Access Compliance Report

Public Rights-of-Way

(Curb Ramps)

Intersection ID: 12322	Main Street: HIGHLAND_ST	Cross Street: GREENLAND_AV	Location: NE
ADA ID: 91B7184F38E2	Ramp Type: Combination1	Initial Pass/Fail: Fail	Overall Compliance: No
			Severity Score: 13.75

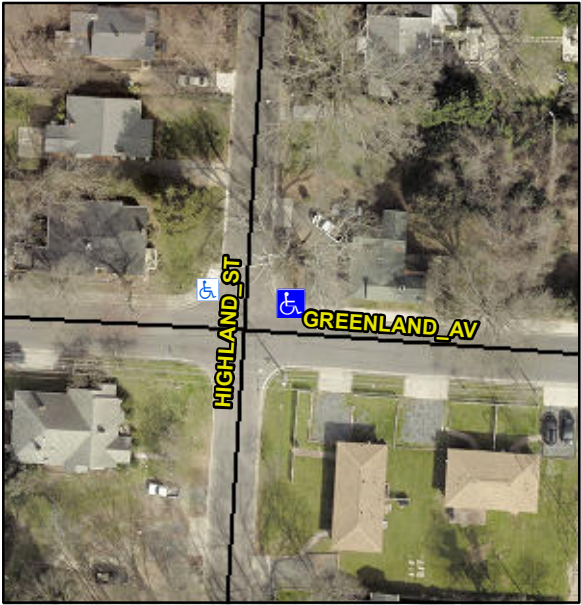
Codes/Mitigation Info/Possible Solution			Field Measurements/Component Compliance		
	Possible Solutions:		Compliance	Description	Data
	Remove & Replace Entire Ramp.		N/A	Ramp Length LT (in)	36.0
			Yes	Ramp Width LT (in)	59.5
			No	Ramp Slope LT (%)	9.5
			No	Ramp XSlope LT (%)	2.6
			N/A	Ramp Length (in)	24.5
			Yes	Ramp Width (in)	48.0
			N/A	Flare Type LT	N/A
			N/A	Flare Slope LT (%)	N/A
			N/A	Flare Traversable LT?	N/A
<p>Surveyor Notes:</p> <p>RT RP < 5%</p> <p>PROW/ADA:</p> <p>Not Found, R304.3.2, R304.5.3</p>			N/A	Ramp Slope RT (%)	4.1
			Yes	Ramp XSlope RT (%)	1.3
			Yes	Ramp Slope (%)	7.4
			Yes	Ramp XSlope (%)	1.2
			N/A	Flare Type RT	N/A
			N/A	Flare Slope RT (%)	N/A
			N/A	Flare Traversable RT?	N/A
			N/A	DWS Provided?	N/A
			N/A	DWS Contrast?	N/A
			N/A	DWS Length (in)	N/A
<p>Street 1 Name</p> <p>Stop Condition-Street 1</p> <p>Street 2 Name</p> <p>Stop Condition-Street 2</p>			N/A	DWS Full Width?	N/A

N/A	DWS Offset (in)	N/A
			N/A	Gutter Slope (%)	N/A
			N/A	Gutter X Slope (%)	N/A
			N/A	Painted X Walk1?	N/A
			No	Painted X Walk2?	N/A
			To W	X Walk 2 Direction	N/A
			N/A	X Walk 2 Width (in)	N/A

1.5	X Walk 2 Slope (%)	N/A
			0.5	X Walk 2 X Slope (%)	N/A
<p>Total Cost:</p> <p>\$ 1800.00</p>			N/A	Ramp inside XWalk1?	N/A
			N/A	Ramp inside XWalk2?	N/A
			N/A	Clear Space?	N/A
			N/A	Clear Space to XWalk (in)	N/A
			N/A	Any Obstruction?	N/A
				Obstruction Type	N/A
			N/A	Storm Grate/Utility Hazard?	N/A
				Storm Grate/Utility Type	N/A
			Yes	Surface Condition? (G/P)	Good
				Curb Slope (%)	8.1
